## Marine Mk IV liferafts — Servicing : *Servicing optimisation (gasket seal, pyrotechnics valises, bellows valise, canopy zips)*

Reason for revision		Page
4.E.	Figures updated.	13
4.F.	Additional information added.	16

This service bulletin tells service stations about new part numbers and how to order them. It also contains information about new techniques for preparing items during packing.

## F. Bellows valise

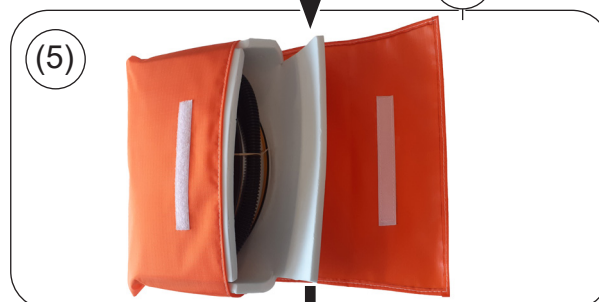
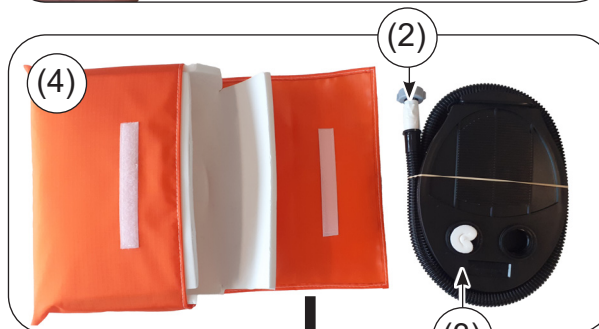
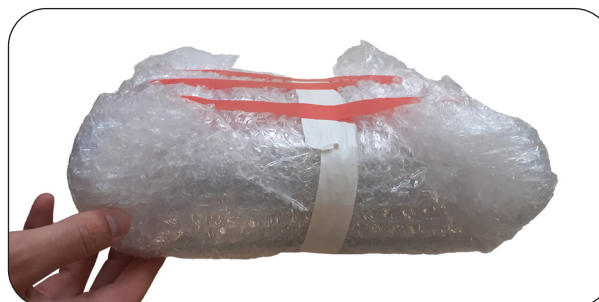
**NOTE:** The packing method that follows applies only to 'pump' style bellows (P/N 45201001 and P/N 45201002). No additional packing is necessary for 'beehive' style bellows (P/N 51784001).

**NOTE:** Position of the bellows remains the same in all instances except for Mk 10 and Mk 14 containers.

- (1) Remove and discard the pillowflex/bubblewrap from the bellows.
- (2) Wind the hose around the bellows so that the screw connector is at the left. Use an elastic band to hold the hose in position.
- (3) Roll a 38 × 19 mm piece of 25 mm plastazote and carefully push it into the DEF port on the bellows.
- (4) Turn the bellows so that the hose's screw connector is near to the bellows valise.
- (5) Put the bellows into the bellows valise so that the hose's screw connector is at the bottom of the bellows valise.
- (6) Fold the flap over to close the bellows valise.
